## Bourns® Sensors & Controls Product Change Notification for Model PDB241-GTR

Riverside, California - August 23, 2011 (REVISED) - Bourns® Sensors & Controls is announcing a change to our [Model PDB241-GTR](#) 24 mm Guitar Potentiometer. The part was previously only marked with the date code on the rear cover. New parts of this model will now have the “**B**” trademark stamped on the rear cover.

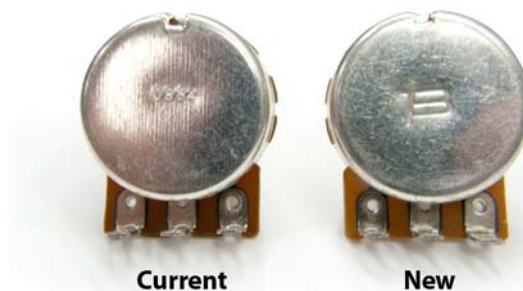
Below you will see the current production part and the new “**B**” trademark stamped part.

The new “**B**” stamped part will begin shipping with all new orders. There is no change in price for the new updated part.
